ITB-18-05
ADDENDUM #1 
2018 OVERLAY PROJECT

Date: March 13, 2018
Bid Number: ITB-18-05
Bid Due Date: THURSDAY, MARCH 22, 2018 BY 1:00 PM OUR CLOCK

(b) Maximum Dimensions

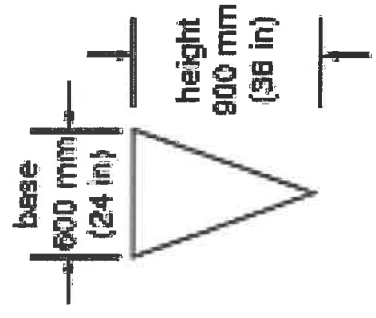
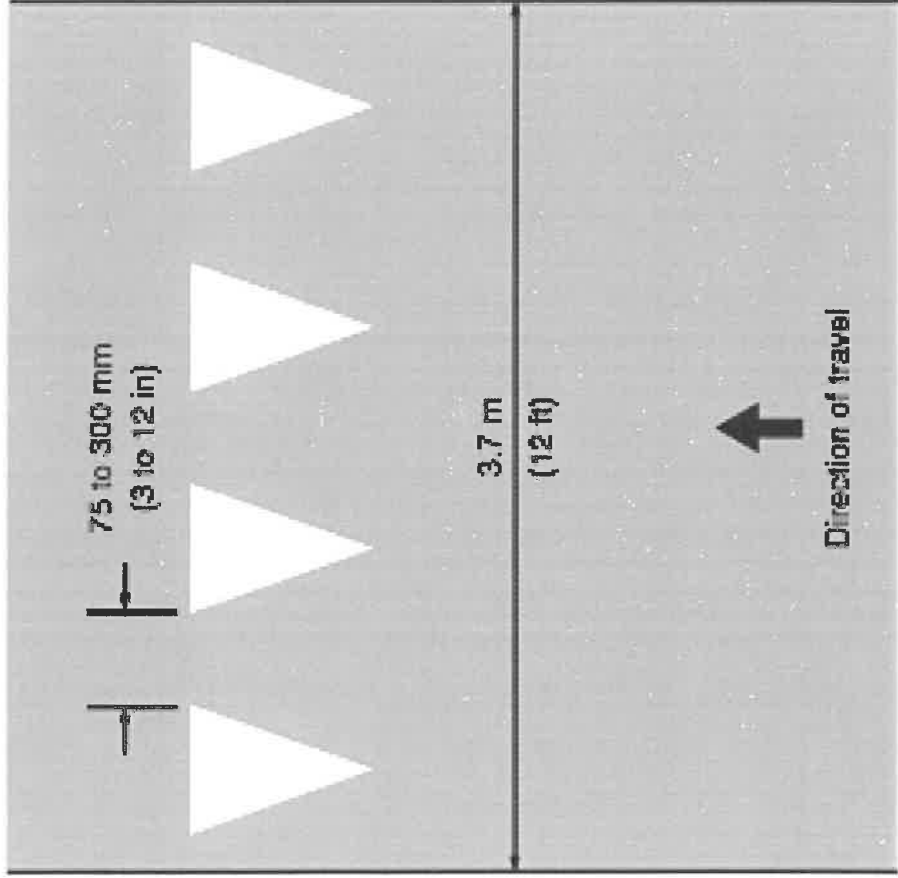
Bidders must acknowledge this Addendum 1 with their bid. It is a total of SIX pages, including three pages of REVISED Bid Schedule forms which MUST be used when submitting a bid. Use of the original bid schedule pages will result in dis-qualification. There is also a detail for the Shark striping.

Triangle height is equal to 1.5 times the base dimension.

Yield lines may be smaller than suggested when installed on much narrower, slow-speed facilities such as shared-use paths.
